# HISTORIC AND DESIGN REVIEW COMMISSION

**HDRC CASE NO:** 2017-385  
**ADDRESS:** 306 E CAROLINA ST  
**LEGAL DESCRIPTION:** NCB 2956 BLK 0 LOT 16  
**ZONING:** R-6  
**CITY COUNCIL DIST.:** 1  
**DISTRICT:** Lavaca Historic District  
**APPLICANT:** Victor Chapa/CMRE Enterprises  
**OWNER:** CMRE Enterprises LLC  
**TYPE OF WORK:** Window Replacement  
**REQUEST:**

The applicant is requesting a Certificate of Appropriateness for approval to replace 23 windows with triple pane vinyl windows; 17 are original wood windows, five (5) are aluminum.

# Window location Chart

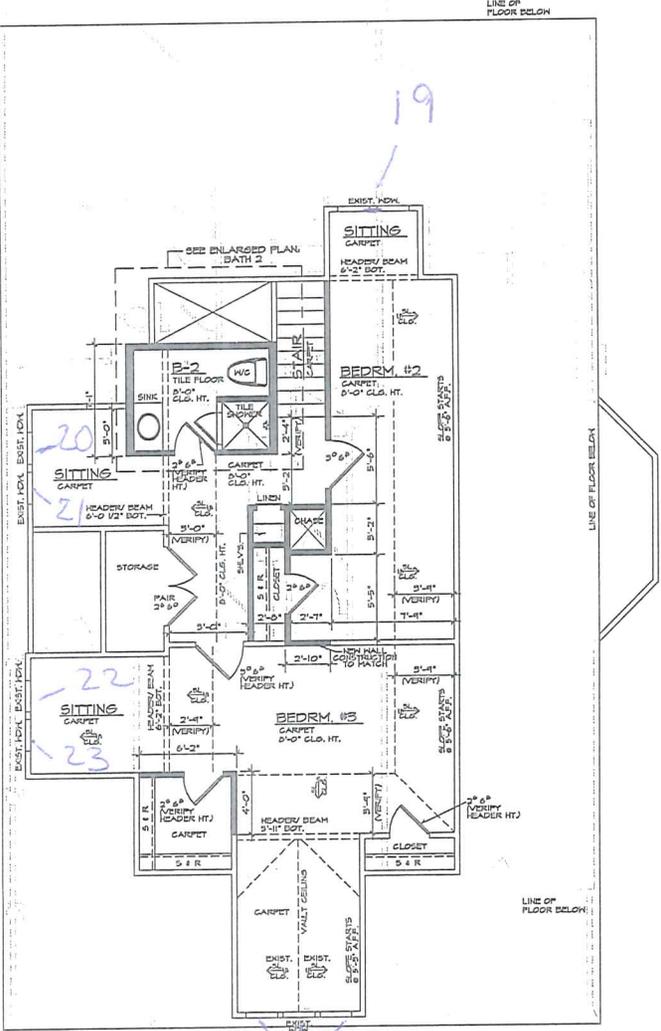
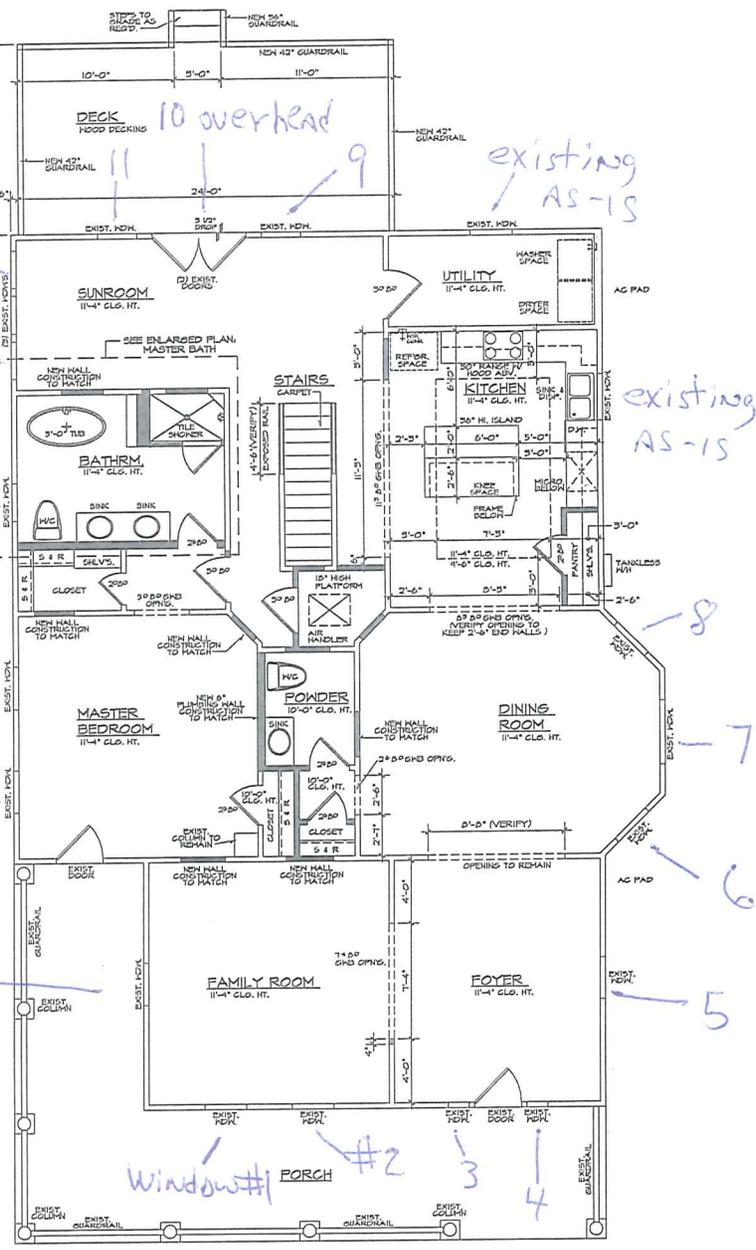
- b. The Guidelines for Exterior Maintenance and Alterations 6.A.i. notes that historic windows should be preserved. Staff finds the removal of the historic windows to be inappropriate and inconsistent with the Guidelines. Staff finds that the historic windows that have been removed are to be repaired and reinstalled. If the removed windows are beyond repair, staff finds that the applicant should reconstruct the historic windows to historic specifications to be reinstalled.

- c. Regarding the existing, aluminum windows that have been removed, staff recommends the applicant install wood windows to be consistent with the Guidelines for Exterior Maintenance and Alterations 6.B.vii.

Staff does not recommend approval of the removal of the historic wood windows. The applicant has not provided sufficient information to warrant any window replacement. Staff recommends that the historic windows that have been removed are to be repaired and reinstalled. If the removed windows are beyond repair, staff finds that the applicant should reconstruct the historic windows to historic specifications to be reinstalled. Additionally, staff recommends that the applicant install wood windows in the dormer openings where aluminum windows once existed that are appropriate for the architectural style of the structure. The applicant is to submit the wood windows to staff for approval prior to installation. Replacement insert windows of any kind are not recommended.
